Work Order ID 87296

Item Name: Crosstube Aft

WORK ORDER NON-CONFORMANCE / UPDATE

CRUSHING OF D412-664-243

DART AEROSPACE LTD	Work Order:	87296
Description: Crosstube High Aft (412)	Part Number:	D412-664-203
Inspection Dwg: D412-664-243	Rev: E	Page 1 of 1

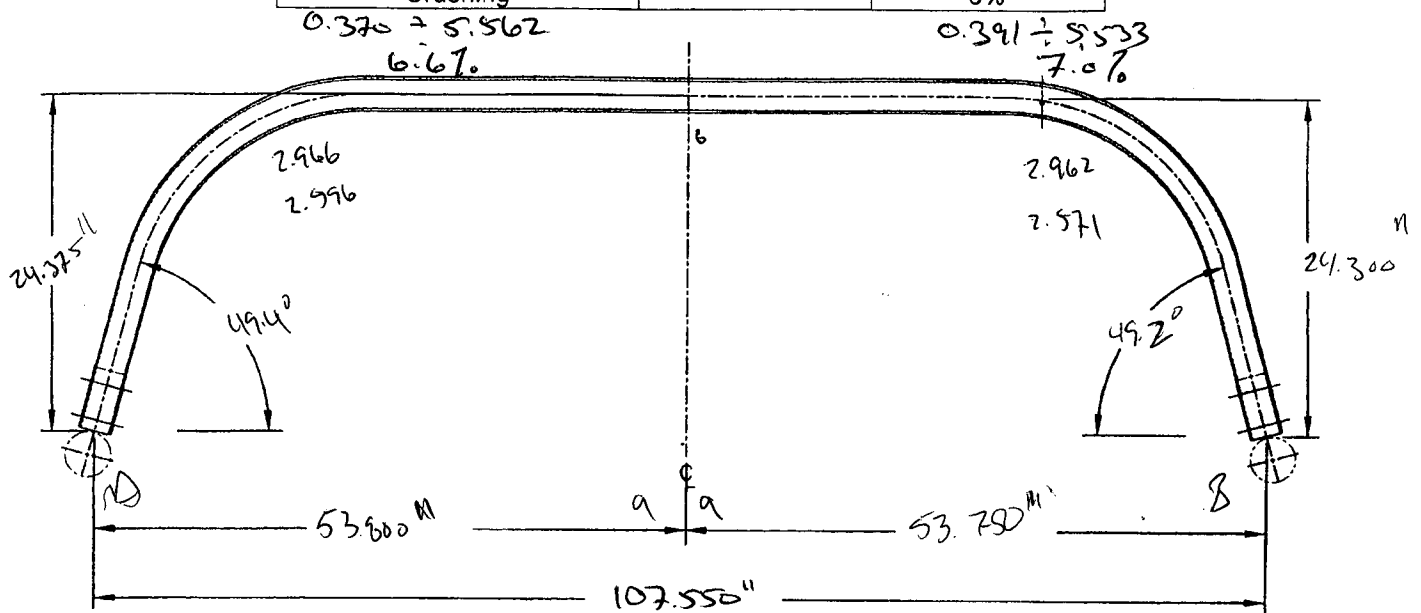
Side A	Middle	Side B
Bending Passes	9	6	9
Crushing	6.6%		7.0%
Comments			
Side A = 9 Passes			
Middle = 6 Passes			
Side B = 9 Passes

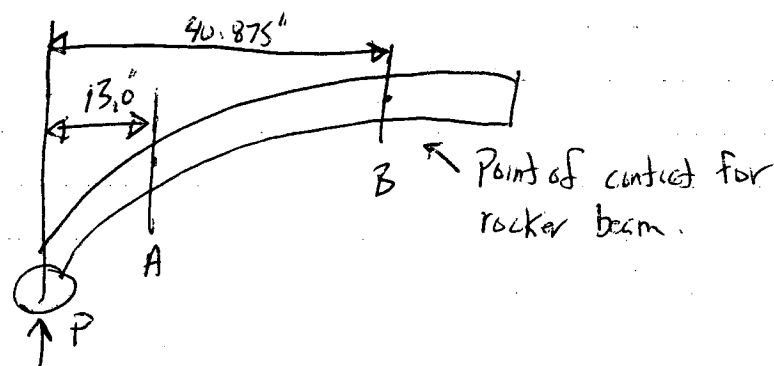
Acceptability of 8% CRUSHING AT END OF BEND

Point A: $OD_1 = 2.961"$, $OD_2 = 2.522"$

$$CRUSHING = (2.961 - 2.522) / (2.961 + 2.522) = 8\%$$

∴ Tube will break at rocker beam contact before area of 8% crushing, 8% crushing in area at end of tube bend is acceptable
